CITY OF WEST TORRENS

# Notice of Panel Meeting

### 6.1 7 Brooklyn Avenue, BROOKLYN PARK

Application No 211/489/2018 & 211/769/2019

**proposed site plan**

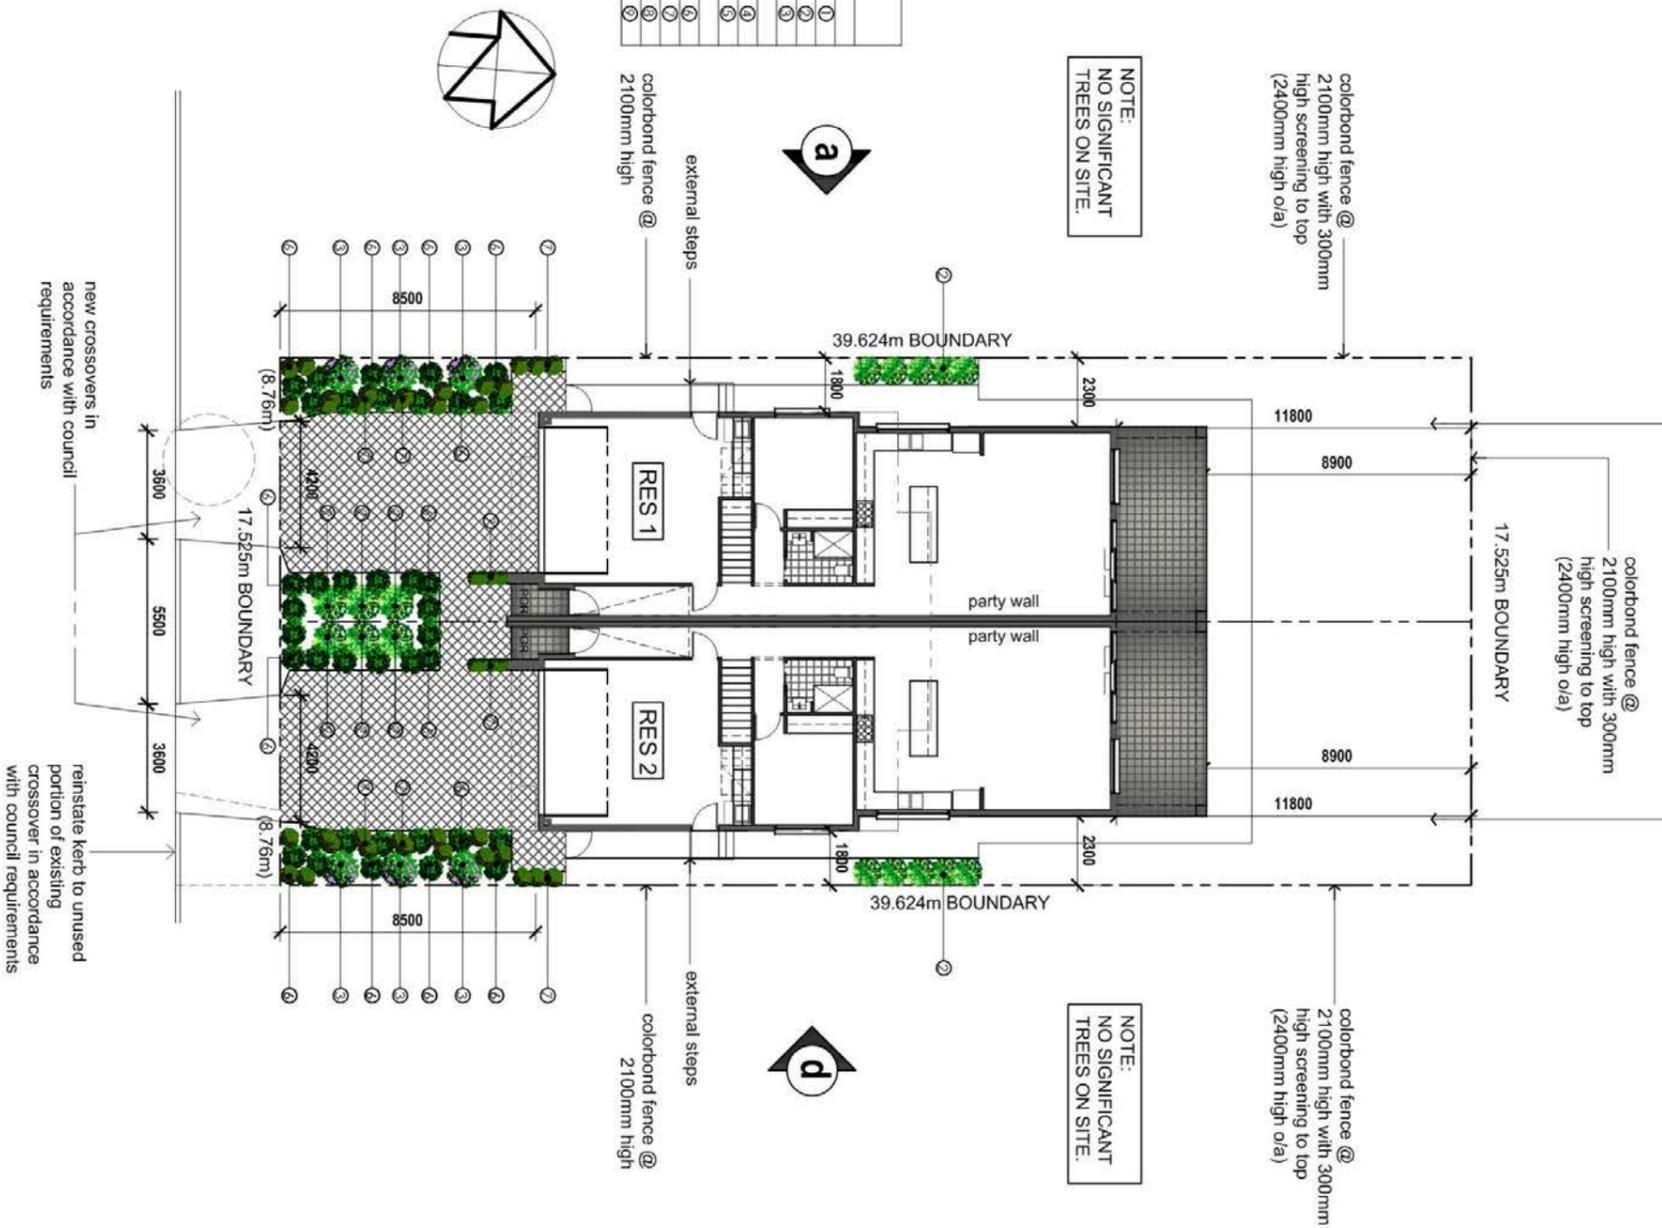
The applicant has provided a detailed landscaping schedule incorporated into the Proposed Site Plan by Inspire Design Studio. Soft landscaping comprises approximately 33% of the development site (assuming the rear yard is landscaped), easily satisfying PDC 4 of the Landscaping, Fences and Walls module. Paving seals the driveways and perimeter paths which is reasonable and expected.

While the plant species indicated are not locally indigenous, the selection includes plant species of varying heights and forms to complement the modern architectural design of the proposed dwellings. A number of trees are incorporated within the development to maximise shade and shelter and assist with climate control around buildings. These trees will also assist in reducing the bulk of the buildings. The driveways have been tapered which minimises hard paved surfaces and allows for notable plantings at the road frontage. Accordingly, the proposed development satisfies PDC 1 of the Landscaping, Fences and Walls module.

4. All landscaping shown on the approved 'Proposed Site Plan' by Inspire Design Studio (Revision: E, Date: 11/10/19), shall be planted within three (3) months of the occupation of the dwellings approved herein.

**proposed lower floor plans**

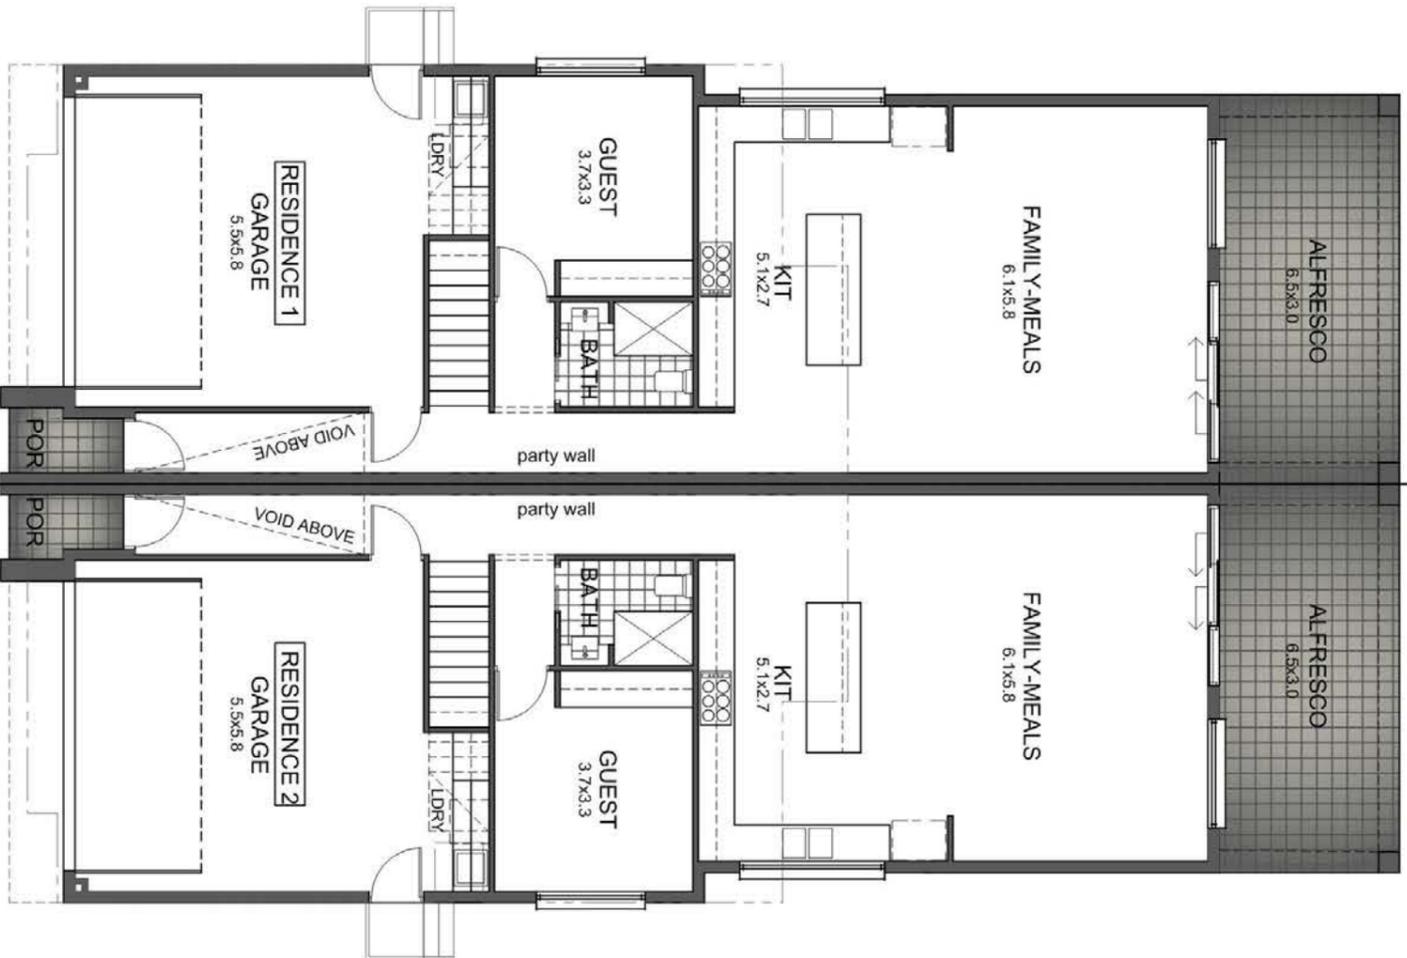
- 3.3 The garage dimension as indicated in 'Proposed Lower Floor Plans' (IDS, Ref: 5044.18-2/4-B, dated 13/12/2018) has been assessed as satisfying minimum requirements.
- 3.4 The garage setback distance as indicated in 'Civil Plan' (Triaxial, Ref: TX12742.31-C1.0-B, dated 24/7/2019) has been assessed as satisfying minimum requirements.

**CIVIL PLAN**  
SCALE 1:200

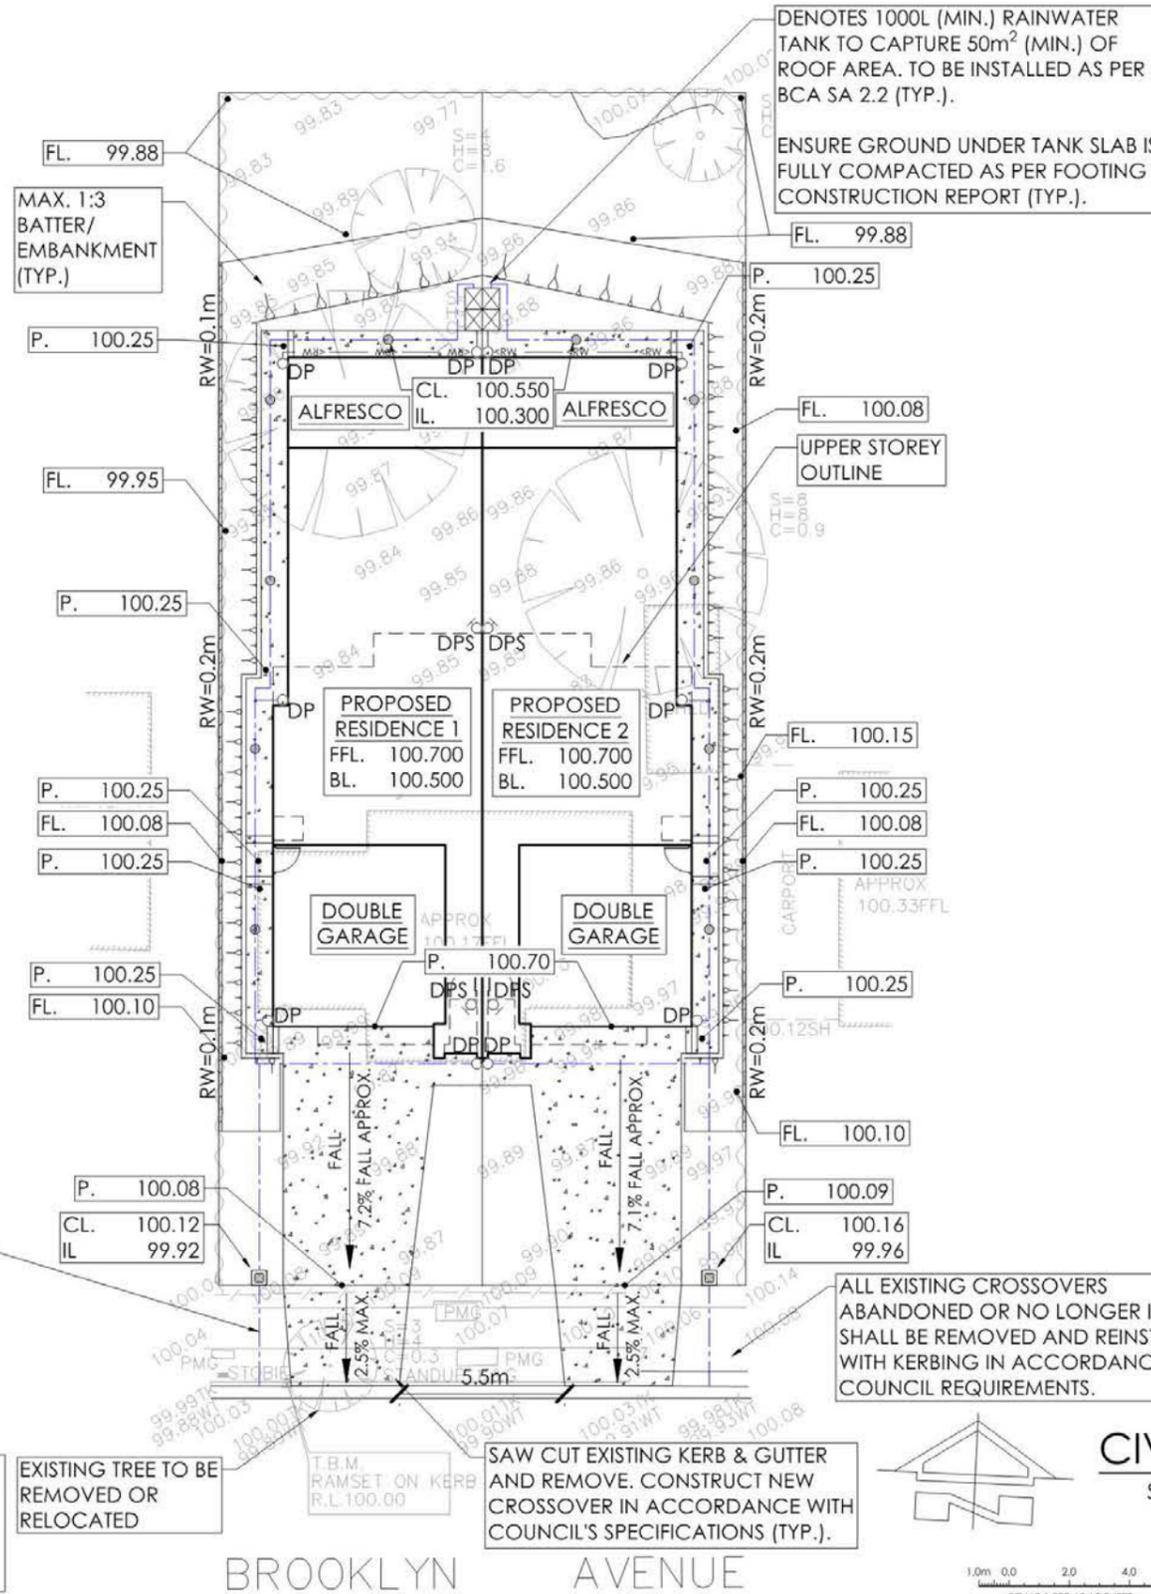
In accordance with the provided 'Civil Plan' (Triaxial, Ref: TX12742.31-C1.0-B, dated 24/7/2019), the FFLs of the proposed development (100.800 minimum) have been assessed as satisfying minimum requirements (100.700) in consideration of street and/or flood level information.

To preserve the ability for flood flows to move through this site, it will also be required that the flood flow corridors indicated above and the general site levels be maintained within 200mm of the existing natural site levels. The only exception to this being the works necessary to provide access into the garage, although the servicing of such access locations must not be permitted to impact on the critical flow corridors.

- 1.3 I noted that the garage opens directly onto the flood corridor area. Given that there will be a height difference of 600-800mm, steps are anticipated for the doorway. These steps should be located in such a way to allow free flow of water within the corridor.

**It would consequently be requested that as part of the application detailed information on the proposed site levels also be provided and include details of ramps and building access.**

- 2.1 Verge interaction has been assessed as acceptable in accordance with the site layout shown in provided 'Civil Plan' (Triaxial, Ref: TX12742.31-C1.0-B, dated 24/7/2019).
- 2.2 It is noted that the portion of existing crossover will be made redundant. This redundant portion of crossover should be reinstated to vertical kerb prior to the completion of any building works at the applicant's expense. It should also be indicated on revised plans that any redundant crossovers will be reinstated.

**It is recommended that revised plans showing the reinstatement of redundant crossovers be provided to Council.**

**It is recommended that revised plans showing an invert flaring crossover (3.6m wide at kerblines with 0.3m flaring towards the boundary on each side - 4.2m wide at the boundary) be provided to Council.**

**It is recommended that the crossover should be relocated to provide a minimum 5.5m spacing between crossovers for on-street car parking.**
